DSG NPS Work Status Meeting

Date: July 30, 2020

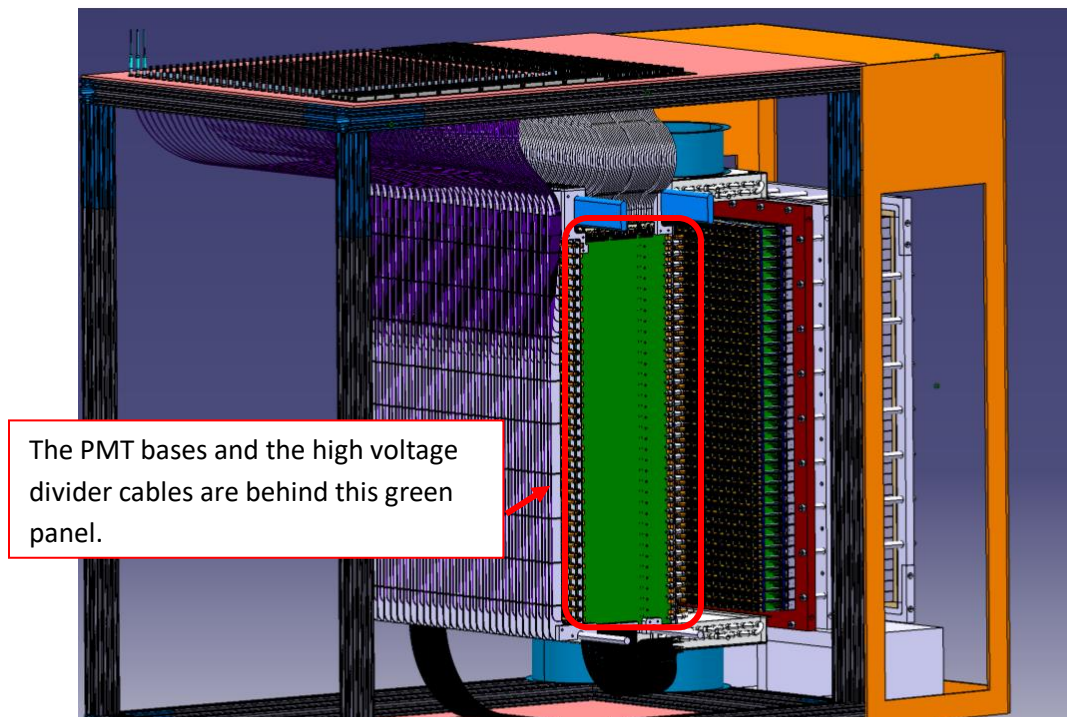
The part in document 1 is actually a cable assembly (PMSD), which comes with connectors and cables. If the DSG is going to be making the cables then we only need the part number for the connectors alone.

Brad believes that the part we should be concerned with is the SAMTEC IPBD units (the connectors that are part of the cable assembly).

Either way, both the PMSD and the IPBD units are only rated to 600 VDC, but the voltage to be used in the experiment is ~1100 VDC. Even though these units have been quality tested to 1000 V (so they *may* be okay), this would definitely trigger some sort of safety review.

Brad is asking if the HV patch panel on the top exterior of the NPS has been fabricated already or if the parts have already been procured. He wants to know if there is still a window to redesign this with new, properly rated connectors.

Finally, Brad asks for a more detailed assembly/design model that shows how the internal connections inside the NPS box are laid out. Specifically, CAD drawings that show connections from the PMTs to the "green panel area" and from the "green panel area" to the interior patch panel on the roof of the NPS structure. *The green panel area refers to the green panel shown in the 3D rendering in document 4.

From [4]. Behind the green panel are the high voltage divider cables that connect to the PMT bases. What is unclear is what the other end of those cables are connected to and how they get connected to the patch panel on the roof interior.

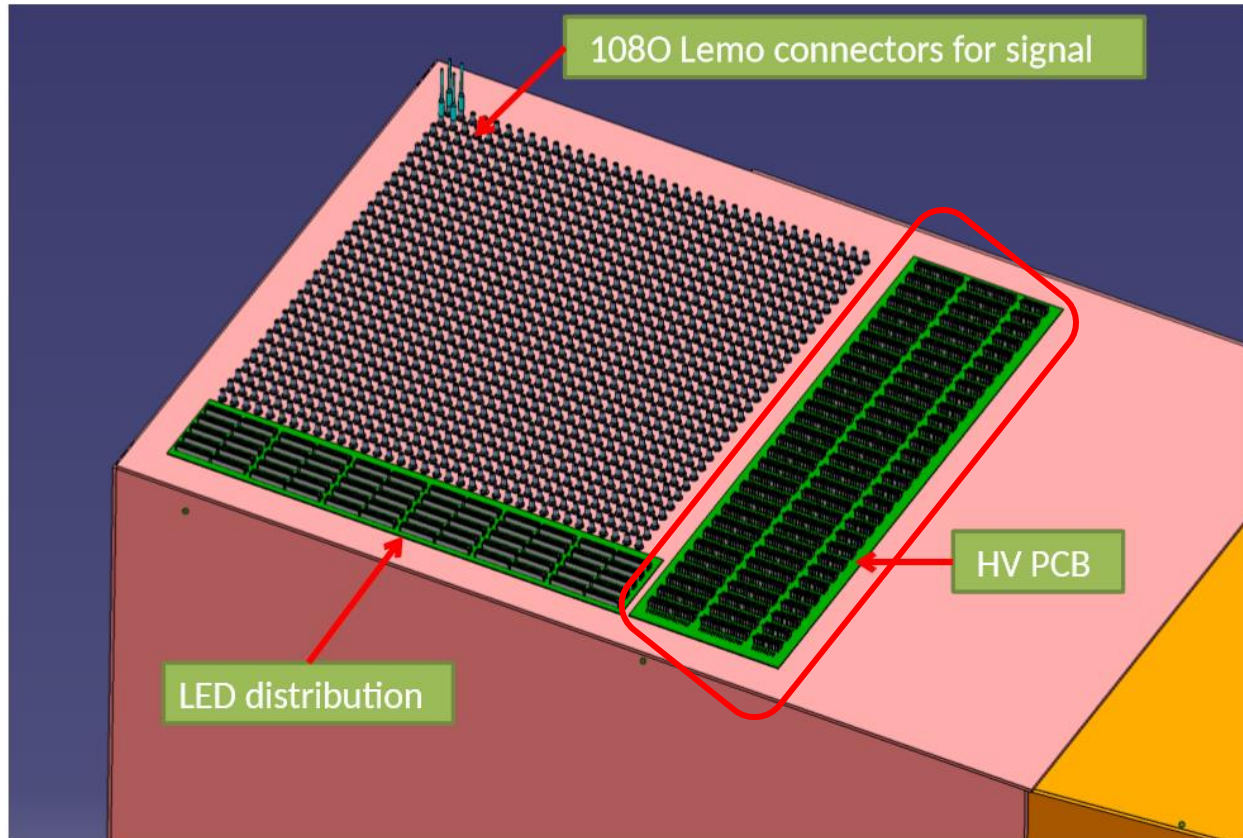
Carlos states that this confusion started because he was thinking about the wrong SAMTEC connector. When we initially asked about the low rated SAMTEC connector he assumed that we were referring to the connector that attaches to the base of the PMT when in fact we were referring to the connectors on the top exterior.

The pcb outlined in red is the location of the SAMTEC connectors in question.

Carlos is going to check the safety specs of the connectors we are actually asking about and get back to us. Carlos states that all pcbs have been fabricated already, but if something is rated too lowly they will absolutely reconsider the design.

As far as the CAD models go, he sent a link to give more insight to how the PMTs are connected and how power goes to the patch panel on the interior roof of the NPS structure until the main engineer comes back from vacation and can send us actual CAD drawings.
